# Service Advisory

CC-557A

### Destroy Service Advisory CC-557 dated December 13, 2006

Subject: **46" Belt / Pulley and Idler Support Bracket Kit, 753-05436A**

**FIGURE 1**

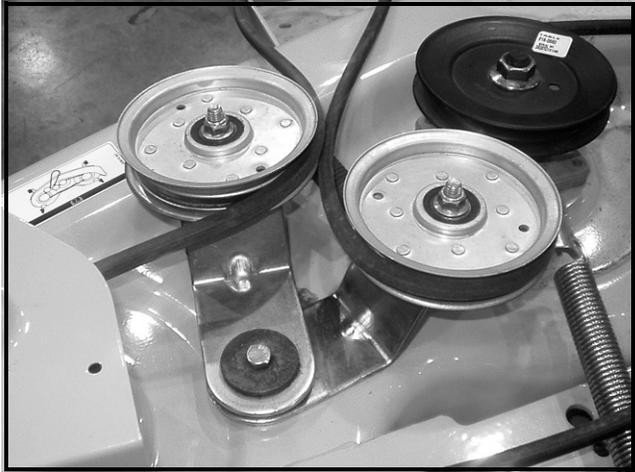
- Under certain loading conditions the two moveable idlers may pull in towards each other sufficiently to result in the deck drive belt inner surfaces rubbing together. This may lead to belt fraying and eventual belt failure. See Figure 1 on page 2.
- There have been a few reports of the deck drive belt jumping off of the idlers. It was found that the upper idler bracket had bent resulting in the upper idler pulley being too low and at an angle for the designed belt path.

**FIGURE 1** - This idler configuration shows none of the upgrades supplied in service kit 753-05436A.

Service kit **753-05436A** contains the necessary parts and hardware to address both symptoms.

The 754-04153 "V" Belt and 756-0627D (3.50" Diameter) Pulley addresses **Symptom 1**.  
 The 783-05463 Idler Support Bracket and 783-05118 Idler Bracket addresses **Symptom 2**.

**FIGURE 2**

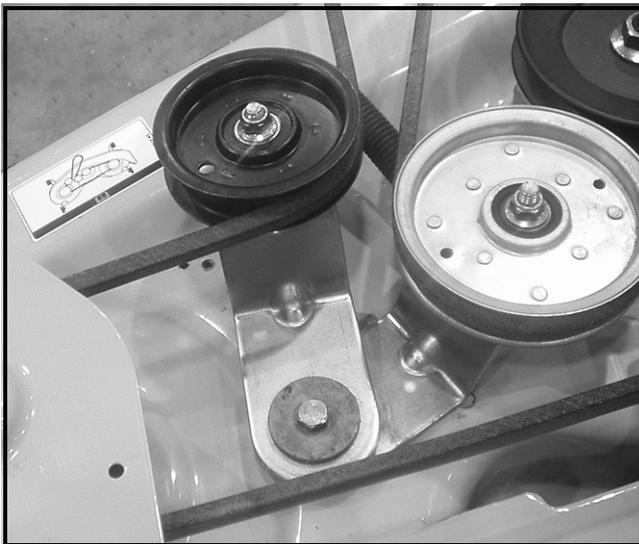
**FIGURE 2** - This idler configuration shows the 756-0627D smaller idler pulley and 754-04153 "V" belt upgrade only installed.

**FIGURE 4**

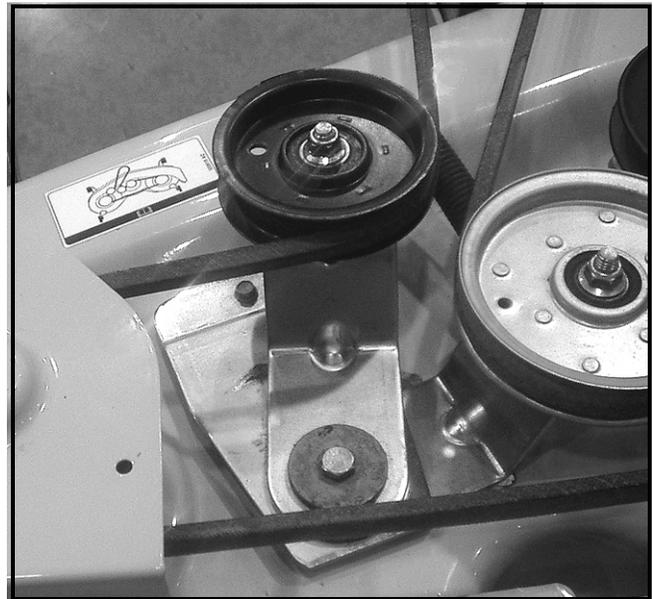
**FIGURE 4** - This idler configuration shows both upgrades supplied in service kit 753-05436A. Installed: 756-0627D smaller idler pulley, 754-04153 "V" belt, 783-05463 idler support bracket, plus 783-05118 idler bracket.

- Some of the **Models Affected** resulted in the 46" decks not having either or some partial upgrade as provided in service kit 753-05436A. See attached service kit instruction sheet.
- Figures 1 thru 3 show possible idler configurations that are affected in the **Serial Number Range**. Figure 4 shows the idler configuration with both upgrades installed.
- Review Figures 1 through 3 to determine which matches your deck idler configuration. Determine what parts from service kit 753-05436A are required so that the idler configuration will be as shown in Figure 4. The new idler bracket, 783-05118 supplied in the kit, should be replaced in all cases.
